FILE: CSSTP-0007-00(494) **OFFICE:** Engineering Services
P.I. No.: 0007494
Douthit Ferry Road Widening **DATE:** February 1, 2013

SUBJECT: IMPLEMENTATION OF VALUE ENGINEERING STUDY ALTERNATIVES

SUBJECT: RESPONSE TO VALUE ENGINEERING STUDY ALTERNATIVES

Douthit Ferry Road Widening
City of Cartersville
Bartow County
CSSTP-0007-00 (494) – PI No. 0007494

Attachment for P-5 – Transportation Enhancement Project Locations
 (Cont.)

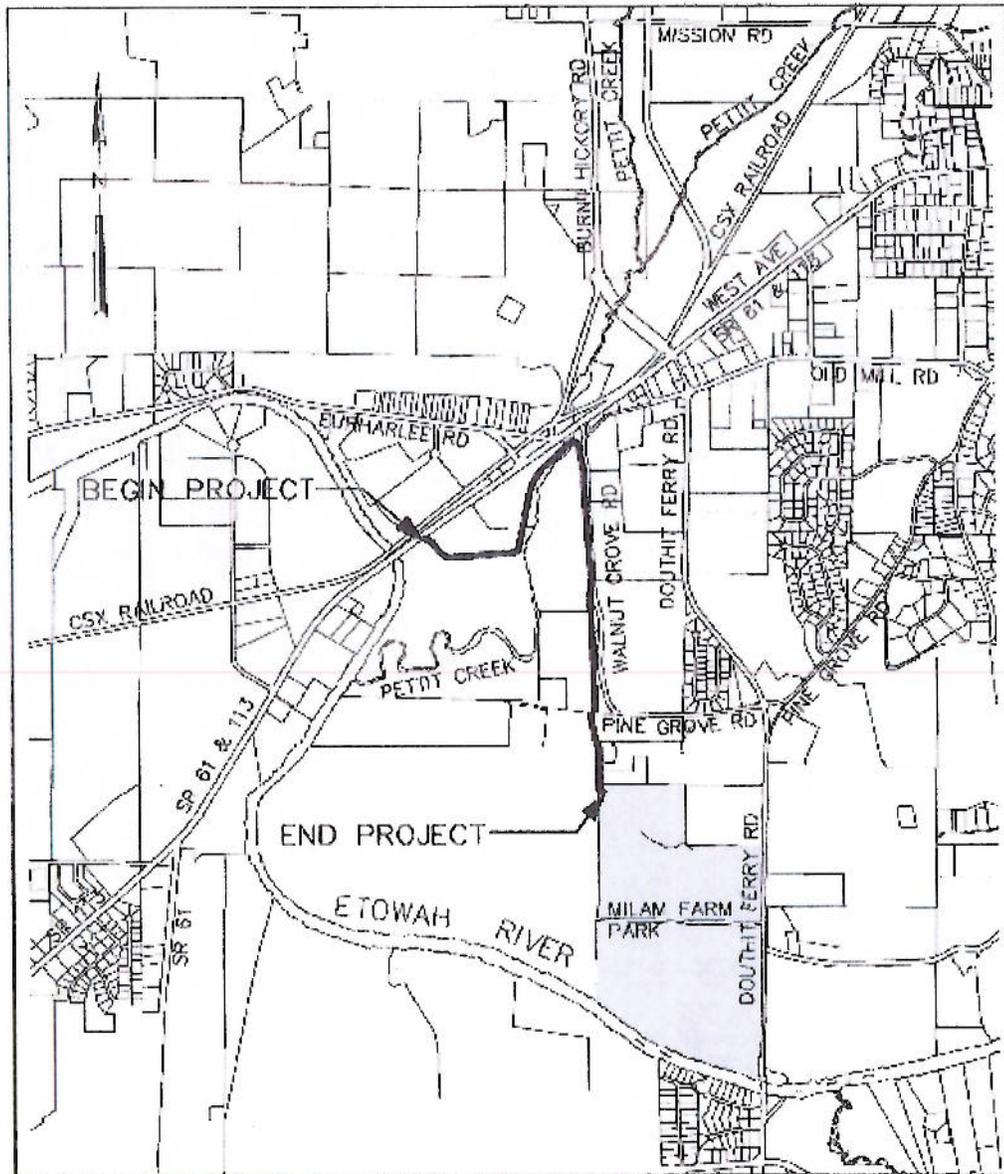
Recommendation P-5: Use multi-use path and remove on-road bike lane from the bridge to the roundabout
VE Team Savings: \$139,000

No, will not implement. We are following the guidelines set forth in the Complete Streets Design Policy on page 9-16, Chapter 9.4.1. Pedestrian Warrants and page 9-25, Chapter 9.5.2 Bicycle Accommodation Design, Item 3. Shared-Use Paths. The Design Policy Manual states on page 9-25 under Section 3. Shared Use Paths that shared-use paths are intended to supplement a network of on-road facilities and should not be used as an alternate for an on-road bikeway. Page 9-16 and 9-17 have standards and guidelines that this corridor meets. 1. There are pedestrian and bike traffic generators in the area as there are churches schools, residential neighborhoods, and a park. 2. There is evidence of pedestrian traffic along the corridor. 3. The City of Cartersville indicates there is a need for the bike and pedestrian facilities. 4. There are two designated bike routes, Route 125 and Route 145, along the corridor. 5. There are two projects under design in the area now through the Transportation Enhancement Funding Program. P.I. No. 0010700 Bartow is the Petit Creek Trail Phase III. The project begins across SR 61/113 from this project with a sidewalk then a shared-use path and runs north to connect to an existing shared-use path. There is also under design P.I. No. 0008067 which begins at SR 61 / SR 113 approximately 2100 ft west of the Douthit Ferry Road/ SR 61/ SR 113 intersection and runs south until it connects to an existing multi-use trail. This existing multi-use trail connects to Douthit Ferry Road. The location maps are attached. 6. There is Bicycle and Pedestrian Action Items included in Table 6.1 of Bartow/Cartersville Long Range Transportation Plan, there are also

Attachment for E-1 – Partial Implementation of E-1 Calculations

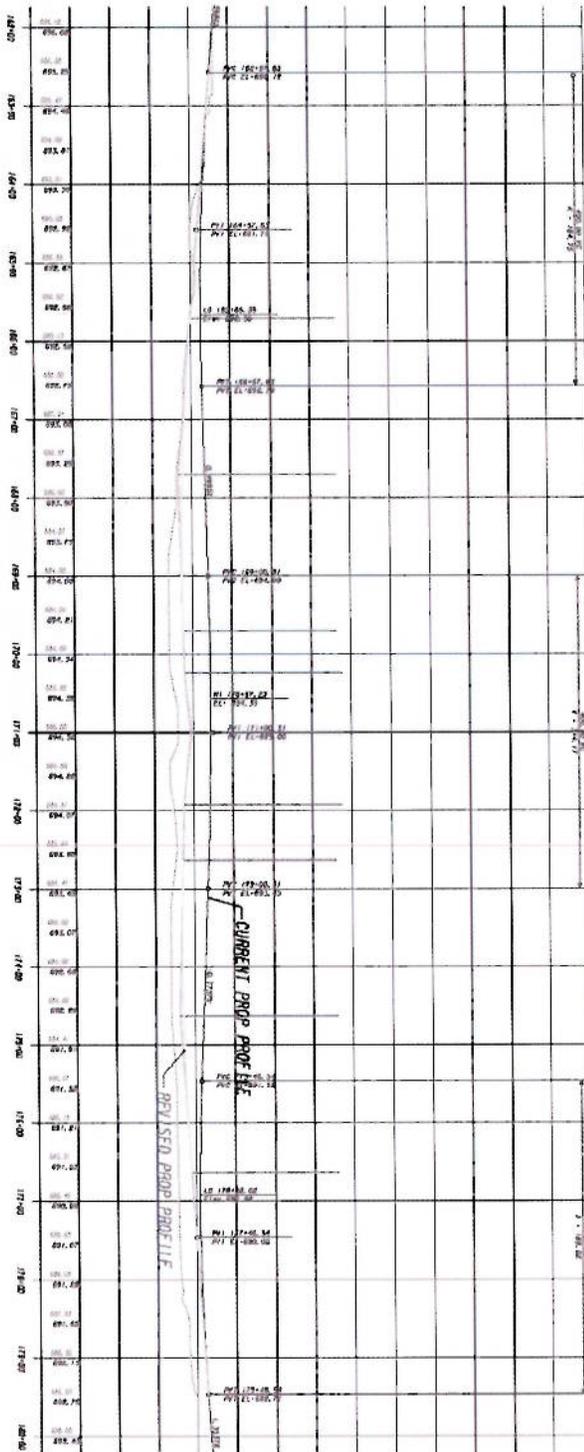
**Recommendation E-1: Lower the grade at the proposed roundabout
VE Team Savings: \$321,000**

Yes, Partial Implementation: The grade will be lowered 5 ft instead of 8.5 ft to allow for positive drainage at the intersection. The revised cost savings are \$254,500. See Attachment for E-1 for calculations. By lowering the grade on Item E-1, the design can be improved on Pine Grove Road. We can improve constructability and reduce the rights of way with a savings of \$170,000. Also Permanent Easement will be used to construct the slopes. This is a savings of \$22,220.00. This is a total savings of \$192,220.00.

Earthwork – Main Line: A reduction of the profile by 5 ft is 60% of the 8.5 ft reduction that was recommended by the VE Study Team, therefore, we will reduce the appropriate VE Study Team values to use 60% where appropriate. (Refer to p.46 of the VE Study Report)

Attachment for RW-4 Calculations

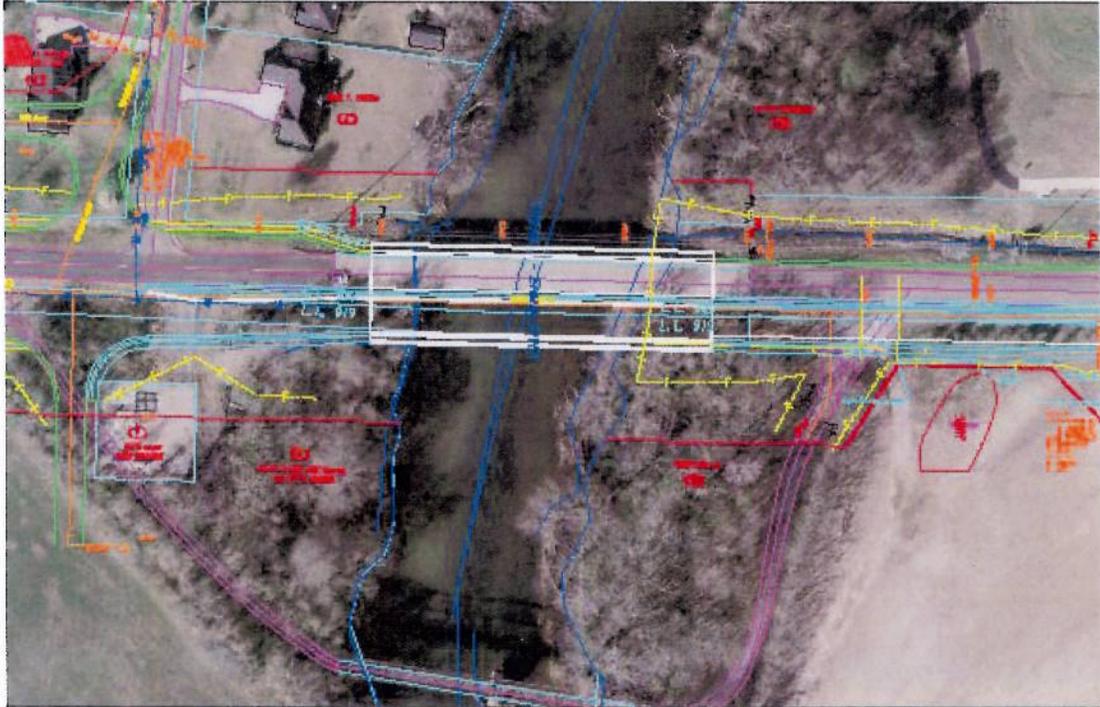
Recommendation RW-4: Realign connection of Park Court to Riverside Court.

No, will not implement; the realignment will not avoid damages on Parcels 5 & 6 and will relocate parcels 46 and 47 as it appears on the sketch shown by the VE Study. The VE Study sketch does not consider the construction of the 12 ft urban shoulders, construction limits, and rights of way necessary to construct the realigned roadway. A new sketch is provided that has the 12 ft urban shoulder, construction limits and approximate rights of way shown. The reduction or avoidance of the administrative fees associated with condemnation filings will not be realized as two condemnations will still be required in parcels 46 and 47 and parcel 6 would still be a condemnation. Also parcel 5 would have damages as the driveway to the house would need to be relocated. So an additional cost of a third condemnation would be necessary. The VE Study estimated \$62,500 per parcel for administrative cost which is based on the ROW estimate in the draft concept report. This amount of \$62,500 would be an additional cost to the project. Therefore since the realignment will not produce the savings as thought by the VE Study and the alignment as designed only produces two condemnations instead of three, it is not recommended to implement item RW-4.

RW-4 will cost an additional \$62,500 to implement
